To: Philadelphia Historical Commission architectural committee
From: Rex Avenue Neighbors Association

Re: 208-210 Rex Avenue development

ARCHITECTURAL SITE PLAN
SCALE: 1"=40'

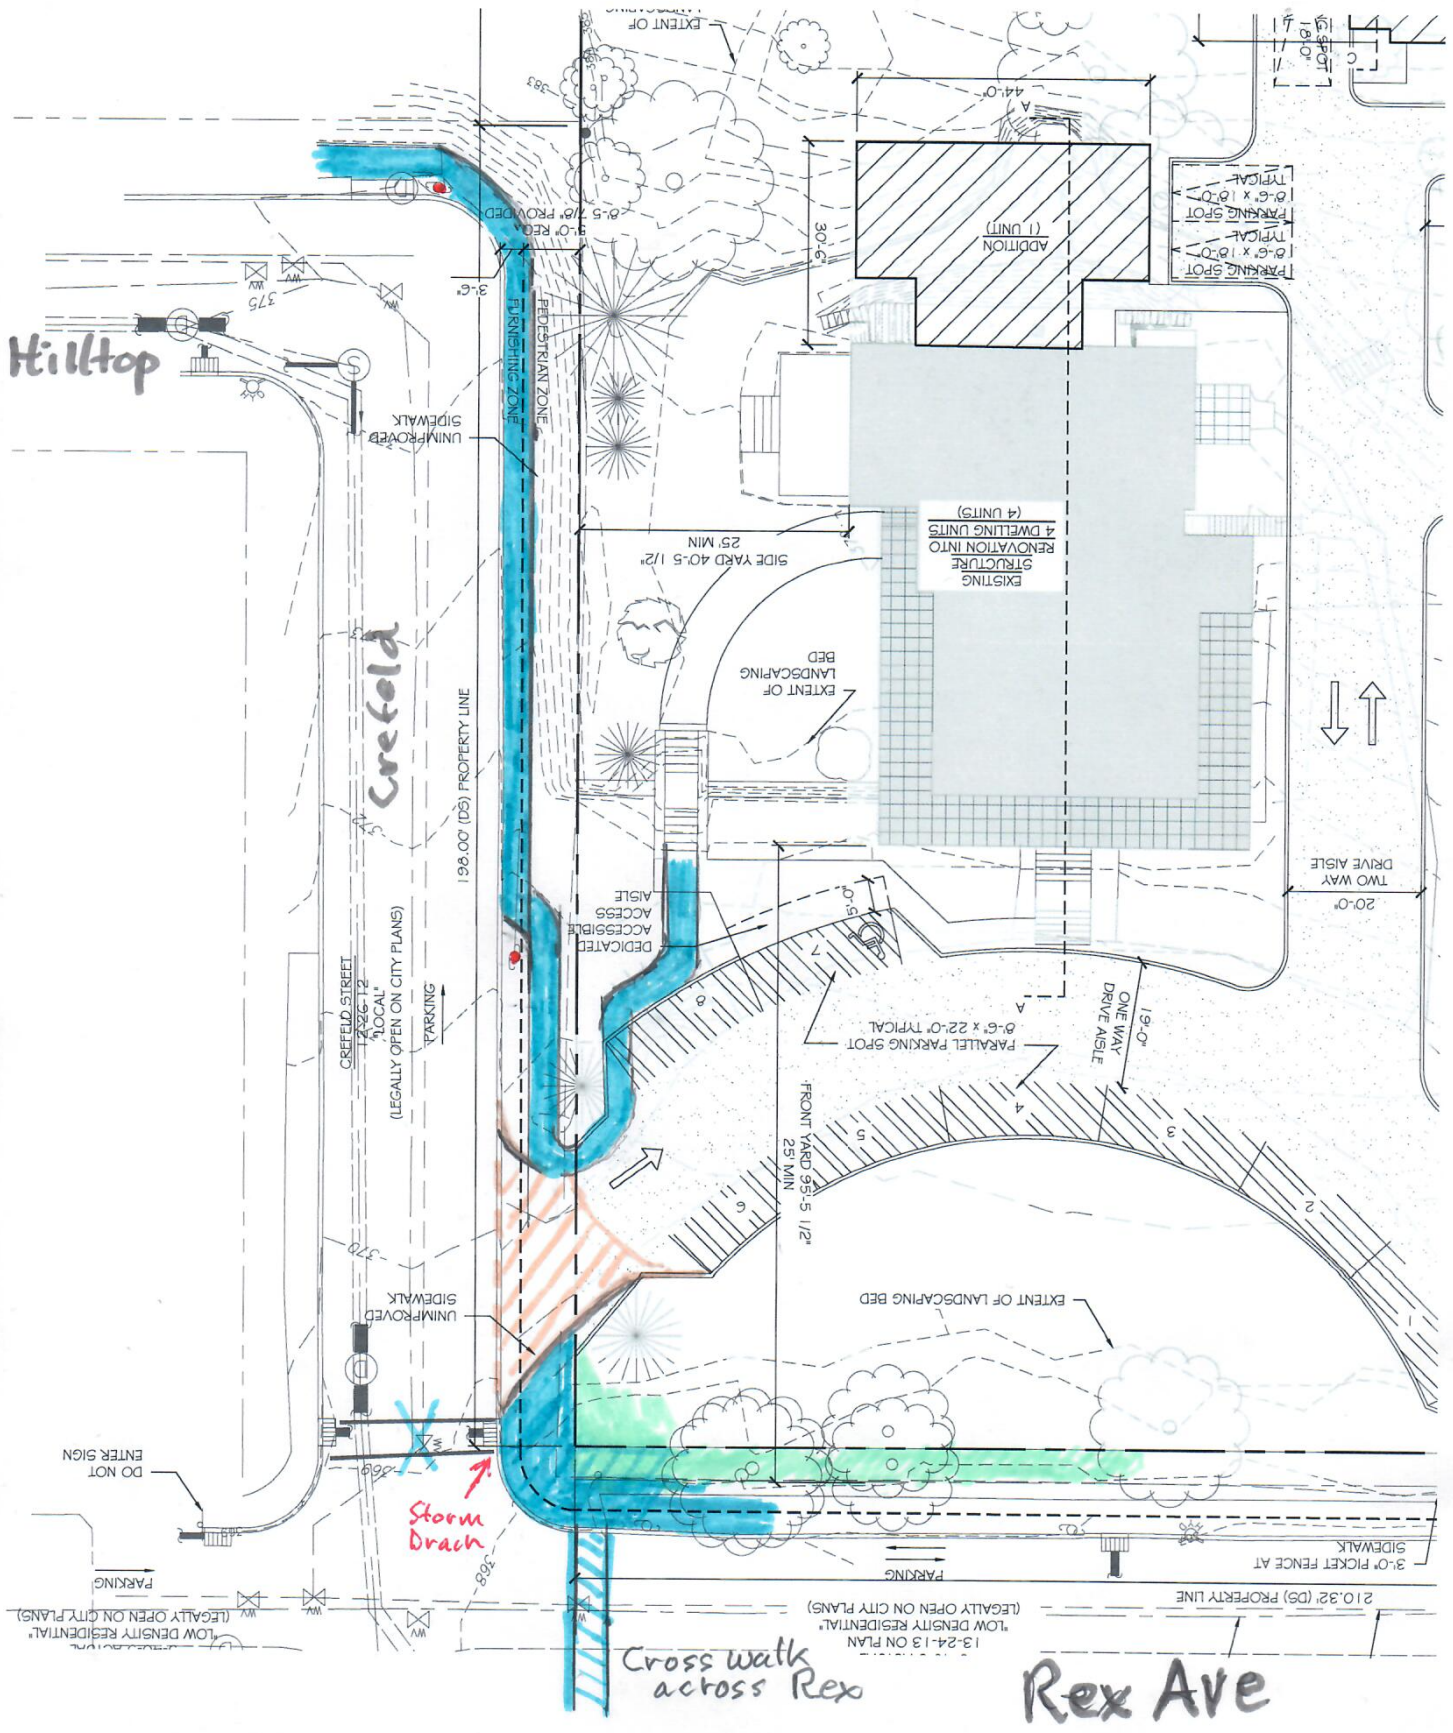
4) We have continued to share with How Group our members' and architectural consultant's aesthetic concerns about the appearance of the driveways, including both the rebuilt circular drive, which was cited in the nomination for the property's historical designation, and the new rearward driveway that runs alongside the historic house. A primary issue was that the current gravel driveway was to be replaced with blacktop, which we believed would present a discordant and jarring appearance.

We are attaching a sketch by our consultant, Matthew Millan, where the red marks indicate how we believe Belgian Block could be used to soften the effect alongside the Hirst-Duhring house and tie all the driveways together aesthetically, without requiring the large expanse of Belgian Block or other paver stones previously considered. In Mr. Millan's conception, which was largely and independently echoed by Patricia Cove, chair of the Chestnut Hill Historical District Advisory Committee, when that committee reviewed the project on March 7, the blocks would border all the driveways; be used as an apron where the circular drive connects with Rex Avenue and Crefeld Street; and provide a transverse interruption in the paving roughly every 30 linear feet. Per the How Group's request, we are not asking that it be considered as part of a drainage plan, as they say that will not be necessary. But if the substrate is permeable, we would

We have also asked that something other than black asphalt be used for the primary paving, and have suggested products that would be more grayish or reddish from the start. We have also suggested that a tar-and-chip surface might be a good alternative. Your committee's further advice on the paving materials would be welcome.

5) We are concerned that while How Group's site plan calls for the current brick sidewalk along Rex Avenue to be rebuilt, it includes no plan for a sidewalk along the side frontage on Crefeld Street. We have urged the Chestnut Hill RCOs to consider working out a Community Benefits Agreement with How Group that would require the developer to continue the Rex Avenue sidewalk around the corner onto Crefeld, extend it the entire length of Crefeld, and connect it into a Hilltop Street sidewalk that appears to end a few feet before the 208-210 Rex property line. As there are no continuous sidewalks on the other side of Crefeld and Hilltop, and the sidewalk in the 100 block of Rex is oddly raised 2 to 3 feet above the street, we believe that providing a continuous sidewalk from the development to the top of Chestnut Hill would benefit both the development's seven new property owners and the broader neighborhood. This walkway would improve public safety and would make this historically protected building — especially the beautiful arched window facing Crefeld from the 1926 Duhring addition — more visible to the broader public. If sidewalks are not beyond your committee's purview, we would welcome your support in encouraging this outcome.
